**Re: *Kennecott Eagle Minerals Company ("KEMC");  
Marquette, Michigan;  
Underground Injection Wells***

# Memorandum

**Subject:** Response to Kennecott Eagle Minerals Company's April 28, 2009 Letter to the U.S. Environmental Protection Agency, Region 5, Re: Response to March 13, 2009 Request for Inventory and Other Information Concerning Proposed Kennecott Eagle Mine

Figure 1. KEMC's conceptual flow model. Note: KEMC's conceptual flow model is based on available information provided in Foth & Van Dyke and Associates, 2006b.

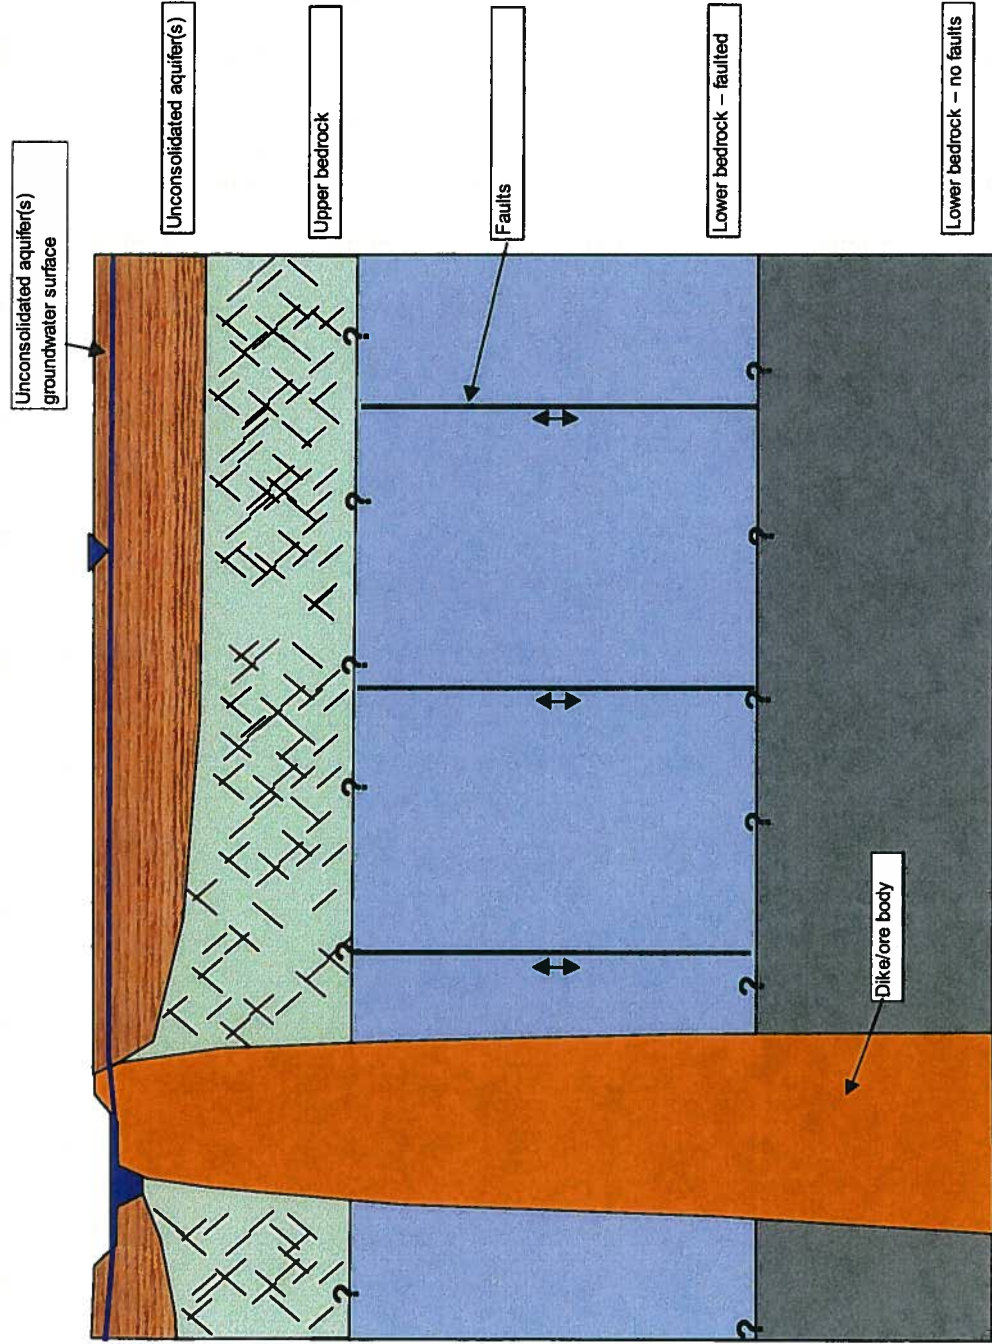
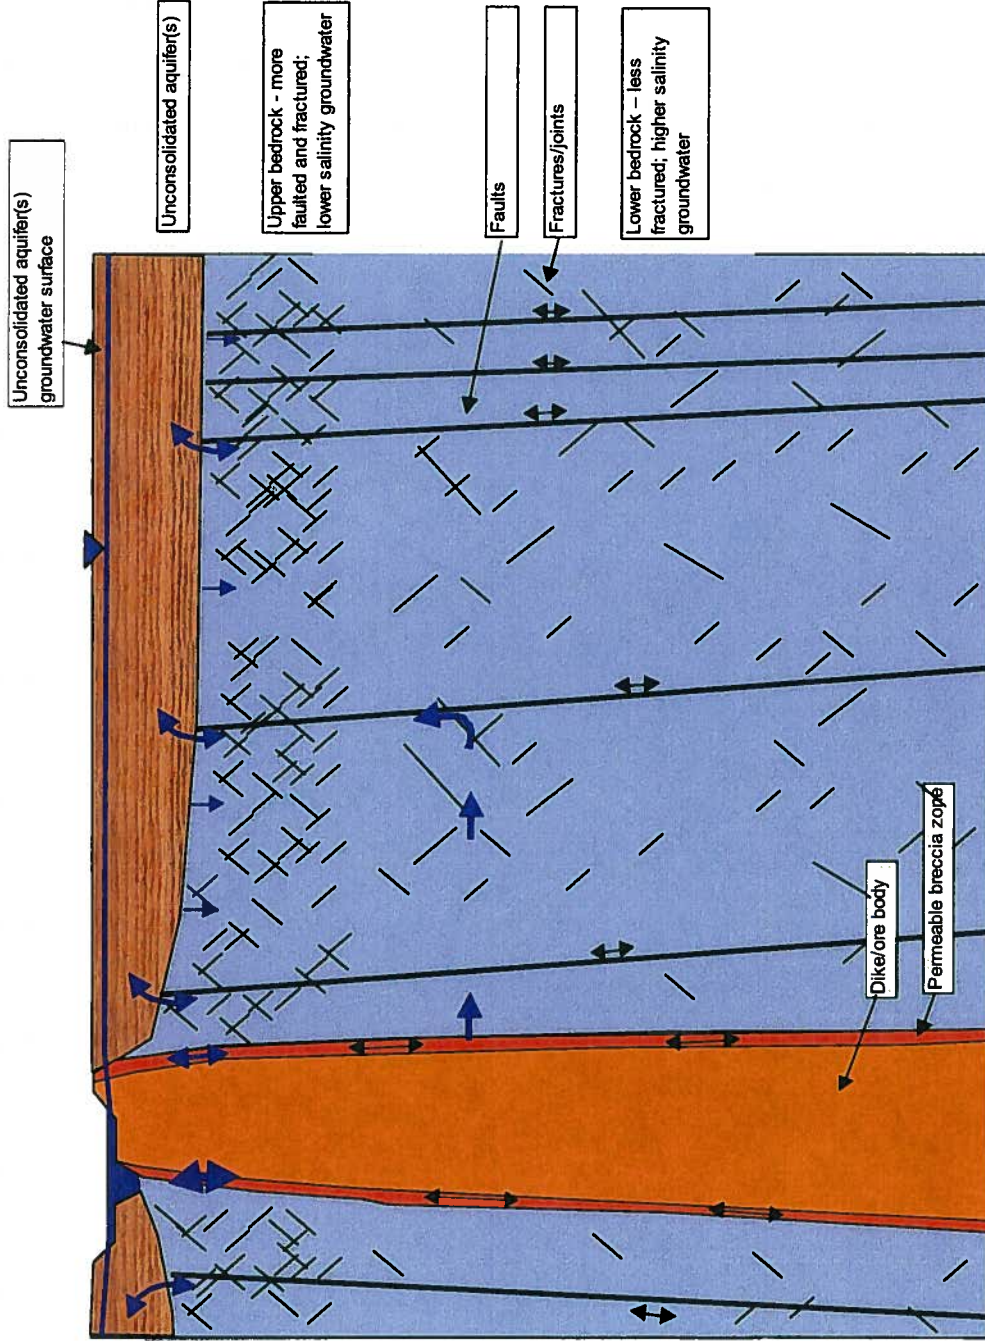
There are notable differences between KEMC's and KBIC's conceptualizations of flow in the bedrock aquifer and flows between the bedrock and overlying unconsolidated aquifers and the Salmon-Trout River. The differences are summarized in Figures 1 and 2. KEMC's conceptual model is shown in Figure 1. In their conceptualization, the upper and lower bedrock have major hydrogeologic and structural differences. For example, KEMC believes that faults exist only in the lower bedrock and do not extend into the upper bedrock, and fractures and joints exist only in the upper bedrock zone. The edge of the peridotite dike/ore body is not noted as being permeable or highly fractured, and flows to and from the unconsolidated glacial aquifer are not noted. In KBIC's conceptual model (Figure 2), there is no difference in rock type and no structural feature or unconformity that define the differences between the two bedrock zones. The faults extend through both the upper and the lower zones of the bedrock aquifer, and enhanced vertical flow is shown along the fractured brecciated edge of the dike/ore body. Fractures and joints are shown in both the upper and the lower zones, and the zones are part of a hydrologically connected bedrock aquifer.

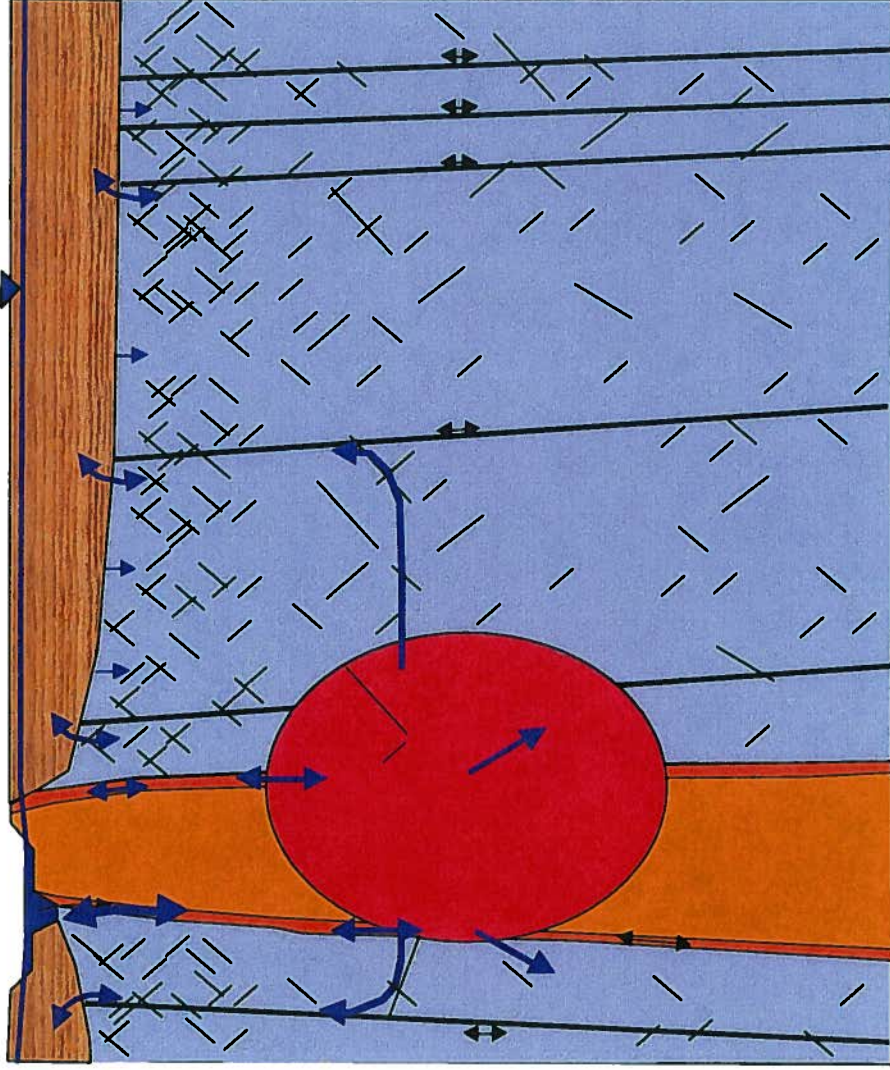
KEMC's conceptual model predicts that water in the underground mine will not move at all after groundwater levels are re-established. KBIC's conceptual model predicts, more realistically, that water will flow downgradient and contaminate the USDW after mining ceases (Figure 3).
